Construction Division
Additions & Alteration Charges Approval Form

Quality Control Check Report. Stage: After Plastering (Apartments)

GULMOHAR RESIDENCY

Details of Additions & Alterations

Description	Direction	Owner's Representative	Date	Prepared By	Prepared By
QC-A-BLOCK-ELECTRICAL PLAN-1360 sq ft FLAT-A1 TYPE	N	Mahesh & Pooja LLP	21.09.2020	Soham Modi	Prepared By
		Project No. 1360	Approved By	N.T.S	Modi Properties Pvt Ltd
		Customer Name	Scale		Phone: 91-40-66335551

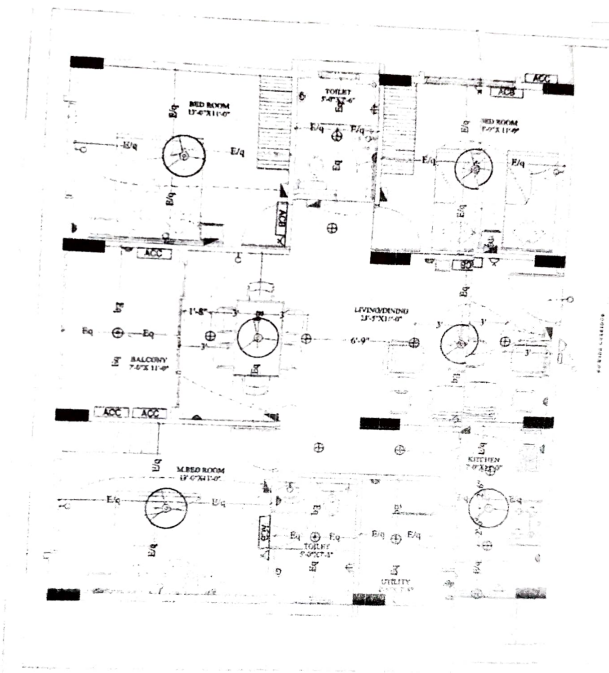
Remarks **NOTE :- 1) In Utility, fasteners to be provide properly.**

Description	Direction	Owners & Developers :	Date :	Promoted by
			Prepared By :	Modi Properties Pvt Ltd
		Modi Reality Mallapur LLP	Jayapradha	
		Project Name & Phase :	Sohan Modi	Phone: +91-40-66335551
			N.T.S

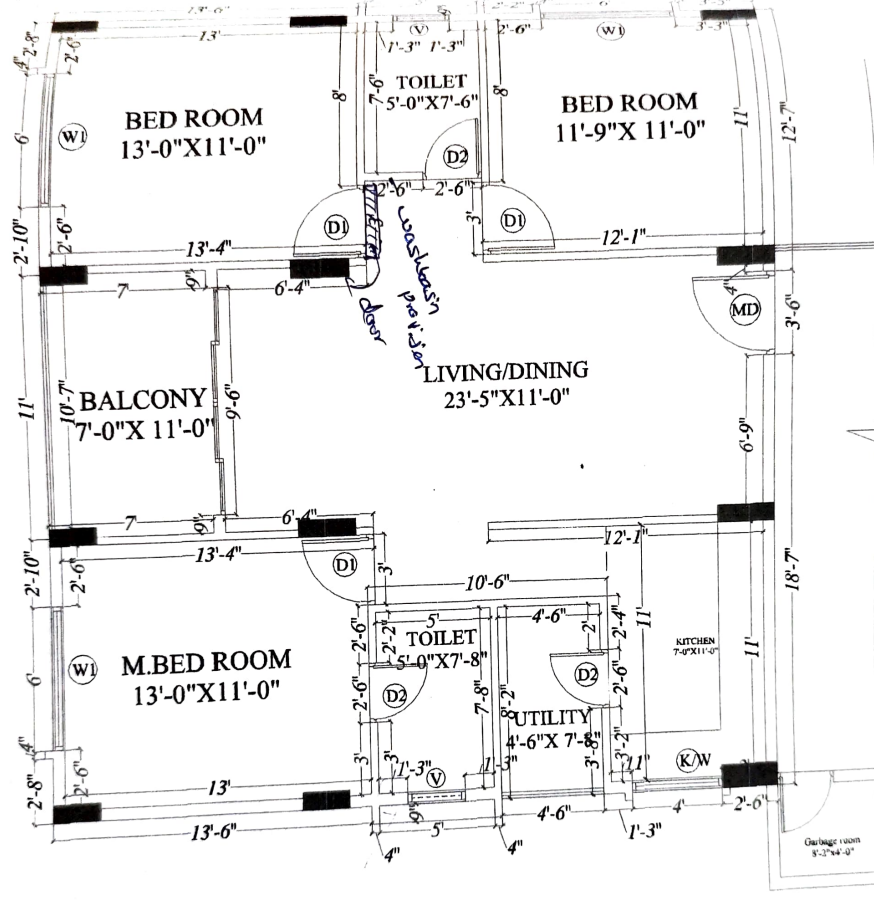
hall, dining bedrooms and kitchen
own customer granite to be laid

2 bathrooms & utility default tiles
to be laid

external s.m.-floor - ultraspinked.

woodwork - floor - blackberry
wood - black outside
